**Closure and Post-Closure Plans
Chemetco, Inc. Facility
Hartford, Illinois**

ENSR Consulting and Engineering

January 1991

Response to IEPA Comments of October 19, 1990 on Closure and Post-Closure Plans, Chemetco, Inc., Hartford, Illinois of July 1990.

FIGURE 3-1
MONITORING WELL LOCATIONS
CHEMETCO, INC. HARTFORD, IL

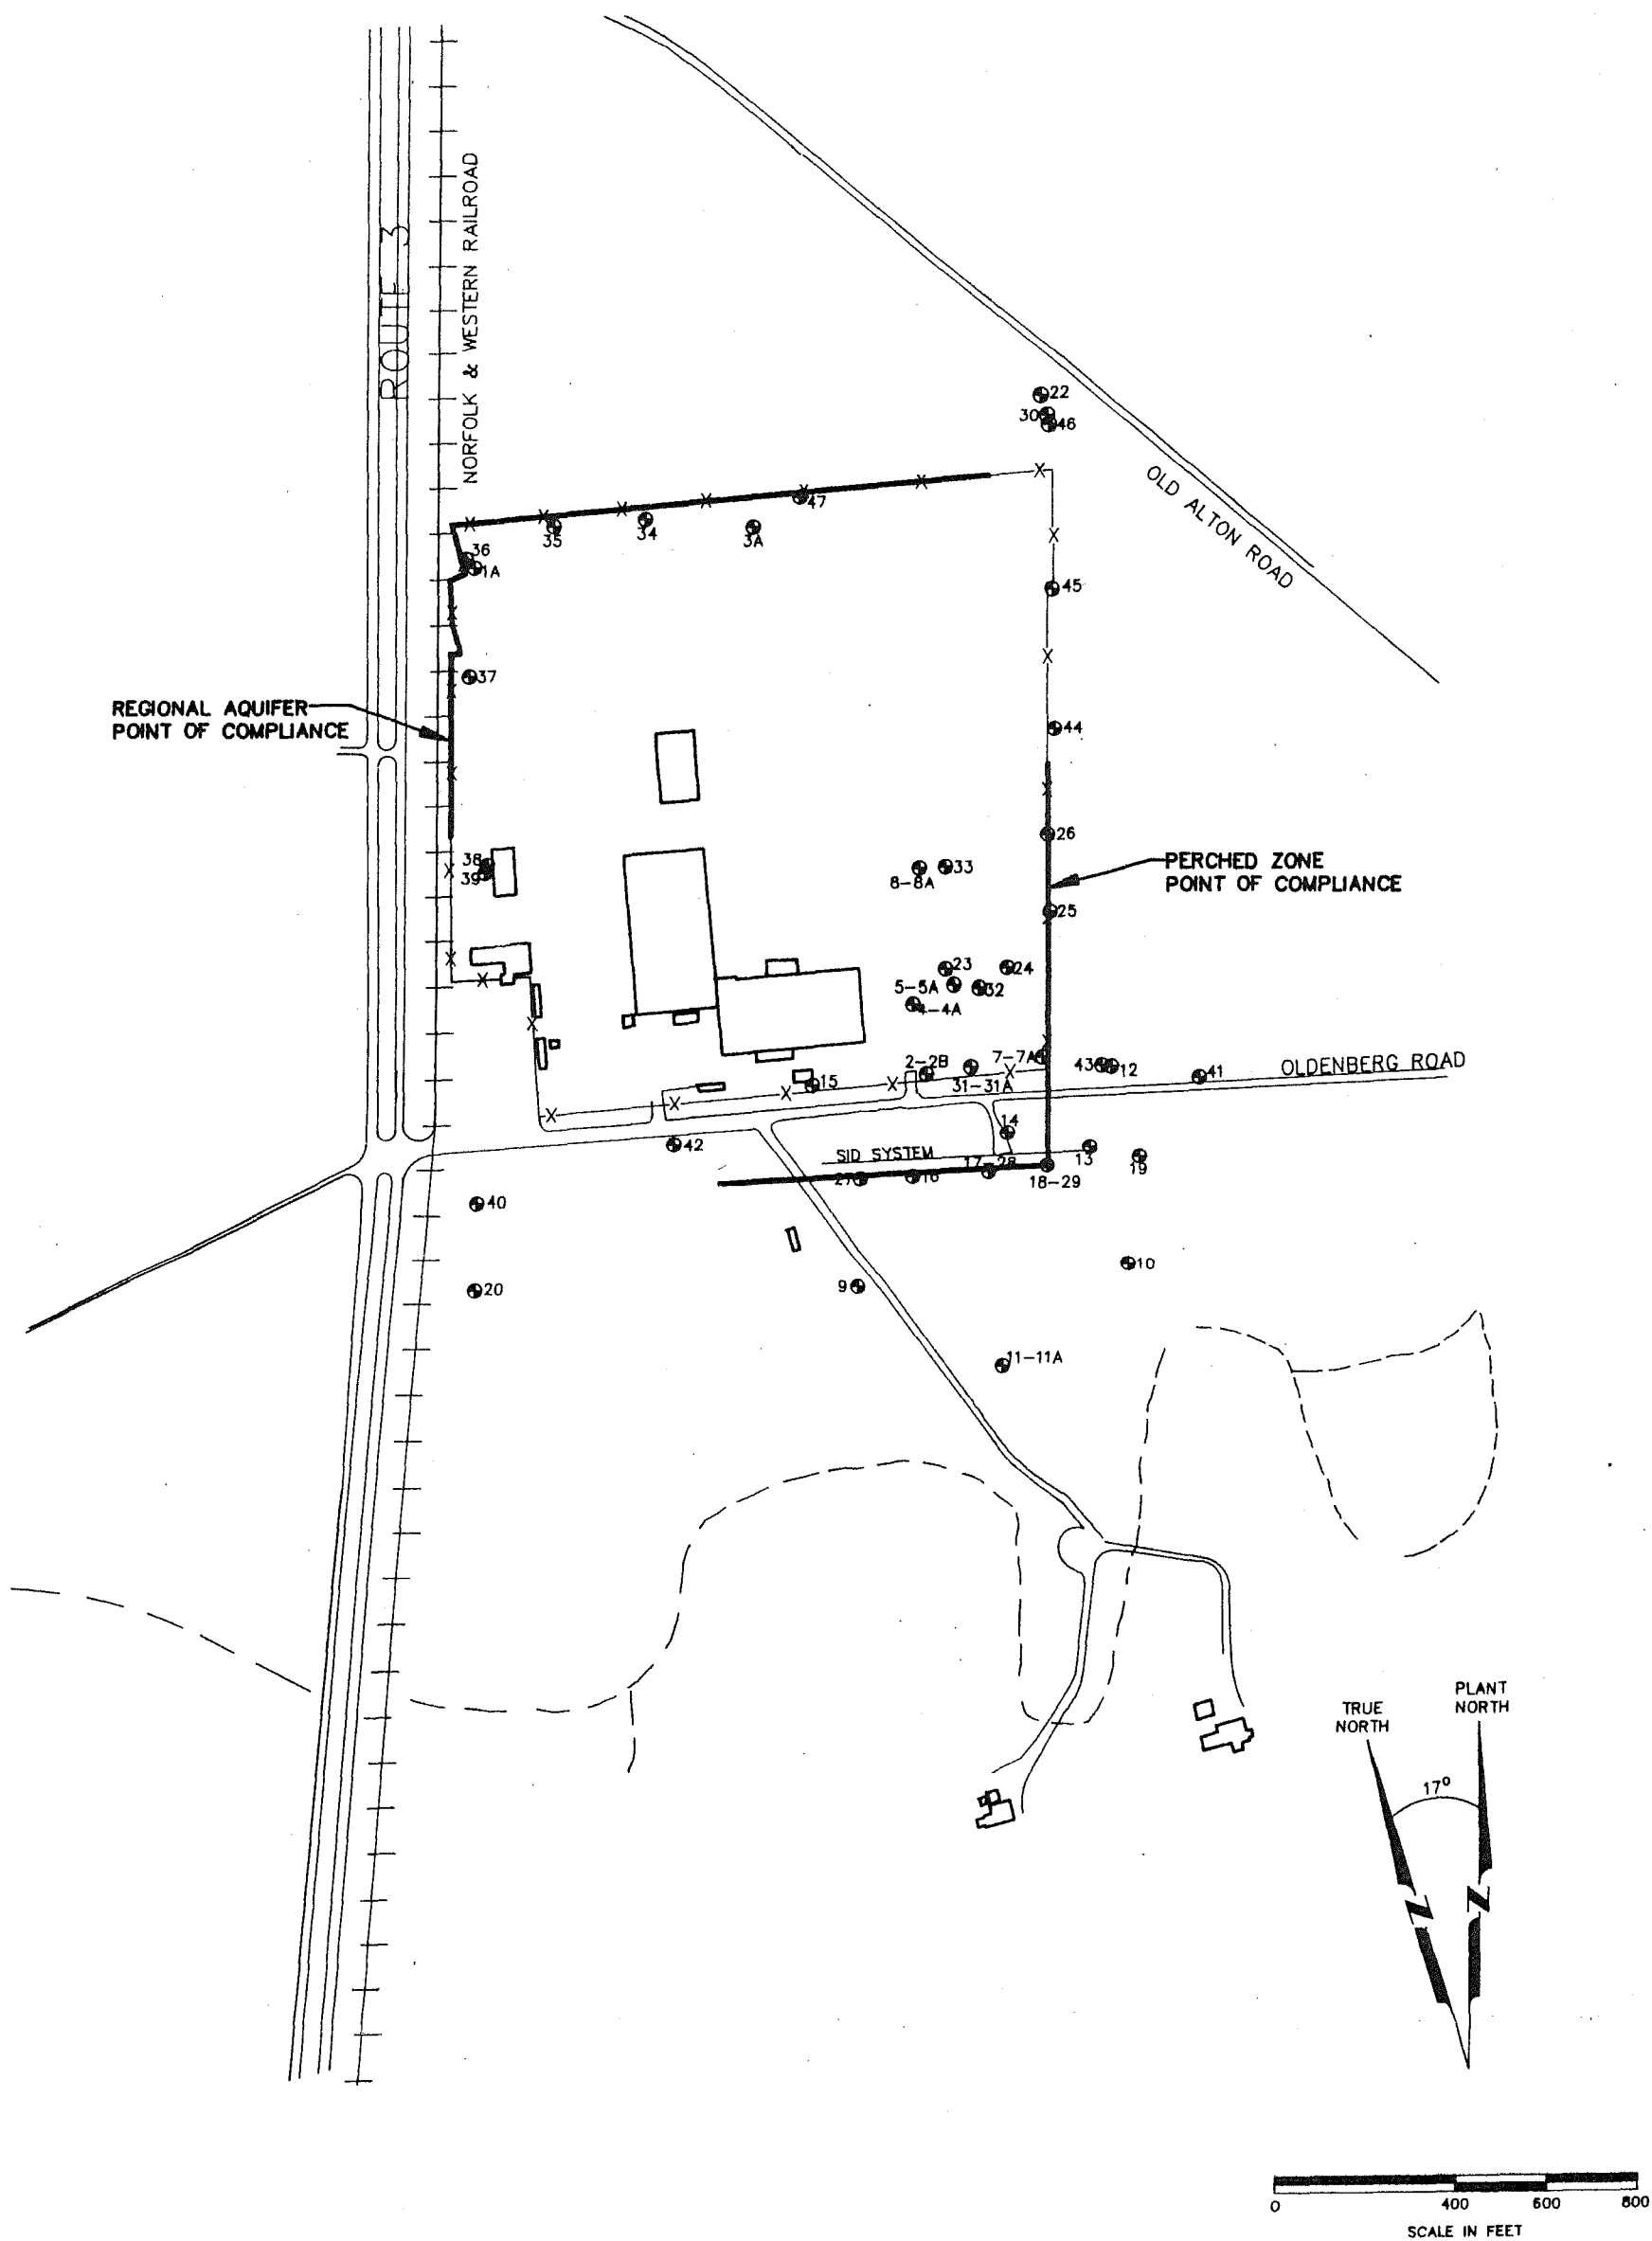
Comment 1.a: Condition 1.v.b of the April 6, 1990 closure and post-closure plan approval letter required Chemetco to provide a map showing the location of wells MW-7 and MW-21. Chemetco responded by stating the well locations are shown on Figure 3-1. However, Figure 3-1 does not show the location of wells MW-7 and MW-21. This must be corrected.

Comment 2.a A map was not provided showing the location of all wells listed in Table 3-1.

Response: Figure 3-1 has been revised to include all monitoring wells at the Chemetco Site. Table 3-1 lists the monitoring wells and provides information on the well depth and screening interval.

Response: A revised map of all the monitoring wells at the Chemetco facility has been included as Figure 3-1.
